REGIONAL MUNICIPALITY OF OTTAWA CARLETON MUNICIPALITÉ RÉGIONALE D'OTTAWA CARLETON

SUBJECT/OBJET CITY OF OTTAWA OFFICIAL PLAN AMENDMENT NO. 21

HERON/WALKLEY AREA

That the Planning and Environment Committee recommend that Council approve Official Plan Amendment No. 21 to the City of Ottawa Official Plan according to the Approval Page attached as Annex II.

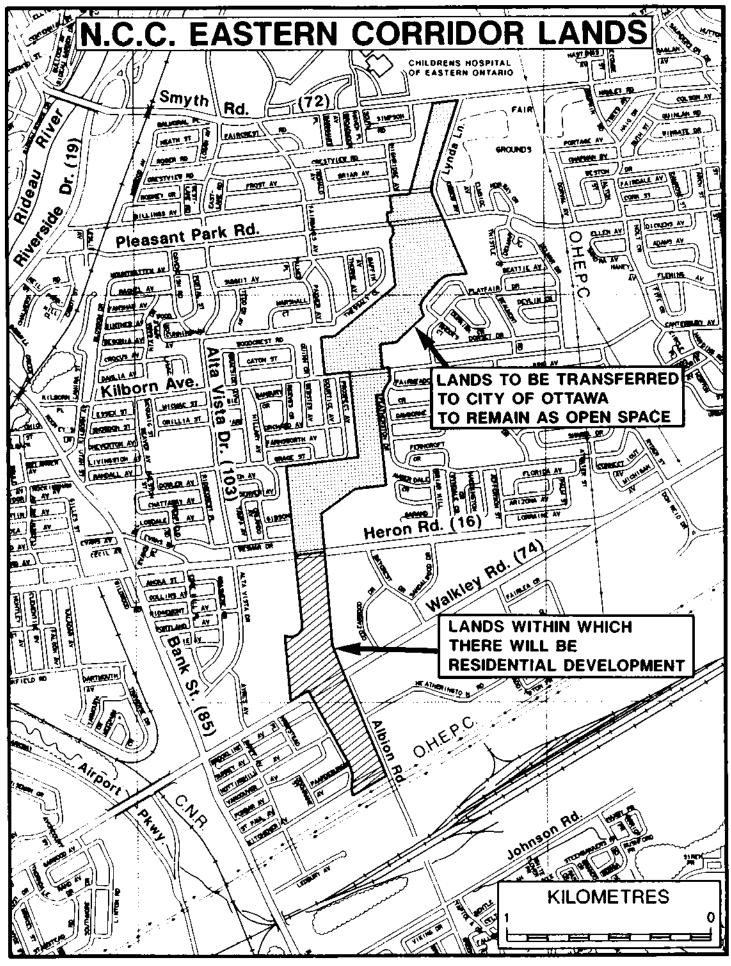
In other "Site Specific Policies" in the City of Ottawa official Plan, the "Figure 1" is given a name.

Schedule "C" is modified by adding the words "Heron Road/Walkley Road Lands" above the Figure 1 where indicated by the Modification No.8 stamp and arrow.

Schedule "C" is modified by adding the words "Heron Road/Walkley Road Lands" above the Figure 1 where indicated by the Modification No.8 stamp and arrow.

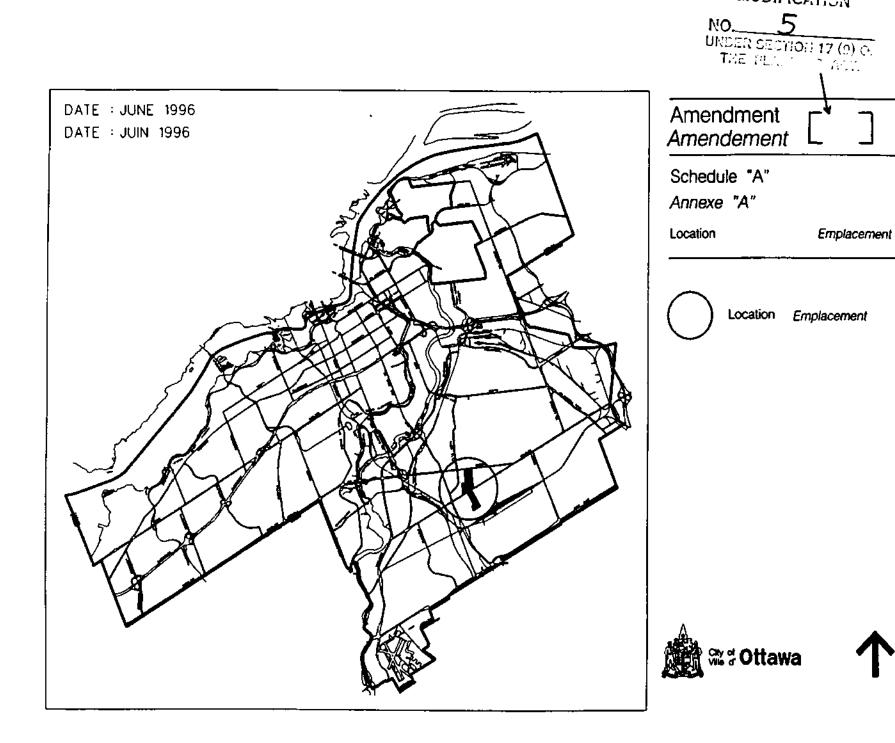
On Schedules A, B and C, there is no reference to the Amendment No. (No. 21) in the title block. This should be added on each schedule next to the word "Amendment" as follows:

It is unclear on Schedule "B" as to which lands fall within the boundary of Amendment No. 21 or that Schedule B, as a base map, is an extract from Schedule "A" to the Ottawa Official Plan. For clarity purposes, it is proposed to modify Schedule "B" as follows:

Schedule "B" is modified by adding the words 'EXTRACT FROM SCHEDULE "A" - LAND USE, OTTAWA OFFICIAL PLAN" at the location shown by the Modification No. 6 stamp and arrow.

Schedule "B" is modified by adding a heavy outline as shown by the Modification No. 7 stamp, with an arrow and information box reading "Area Affected by Amendment No. 21".

Schedules "A", "B" and "C" are modified by adding the number "21" to the right of the word "Amendment" in each of the respective title blocks.

Schedule "B" is modified by adding the words 'EXTRACT FROM SCHEDULE "A" - LAND USE, OTTAWA OFFICIAL PLAN" at the location shown by the Modification No. 6 stamp and arrow.

Schedule "B" is modified by adding a heavy outline as shown by the Modification No. 7 stamp, with an arrow and information box reading "Area Affected by Amendment No. 21".
